## Architectural Commission Report

**Meeting Date:** Wednesday, March 20, 2013  
*(Continued from the AC meetings on February 15, 2012 and April 18, 2012)*

**Subject:** **435 NORTH BEDFORD DRIVE**  
Request for approval of a façade remodel  
(PL1201611)

SHEET NO.  
**A-3**

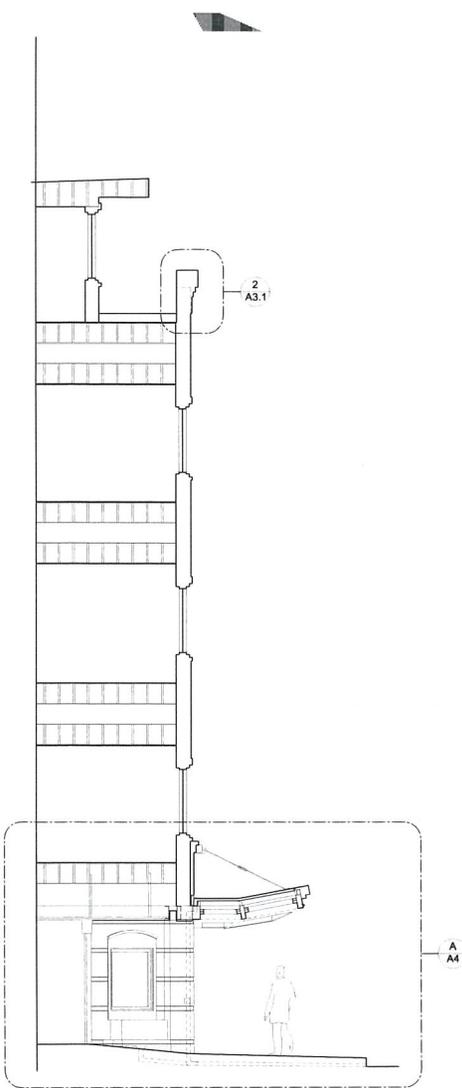
- The existing doors aren't consistent with the style of the proposed design. Consider retrofitting or replacing the entry doors.
- The entry canopy design needs to be further refined. Please provide more detail for the entry canopy. Do the fasteners have enough 'weight'? Does it contain welded steel tubes? Clarify the materials.
- The design needs to be a fit further developed. The canopy, stone and doors should all be making the same statement.
- Provide larger samples of the proposed colors and materials.
- Show how the steel fabric interrupting the building fabric will be handled.

The applicant has prepared a written response summarizing the modifications made to the project in response to the Commission's comments. This summary has been included in Attachment A of this report.
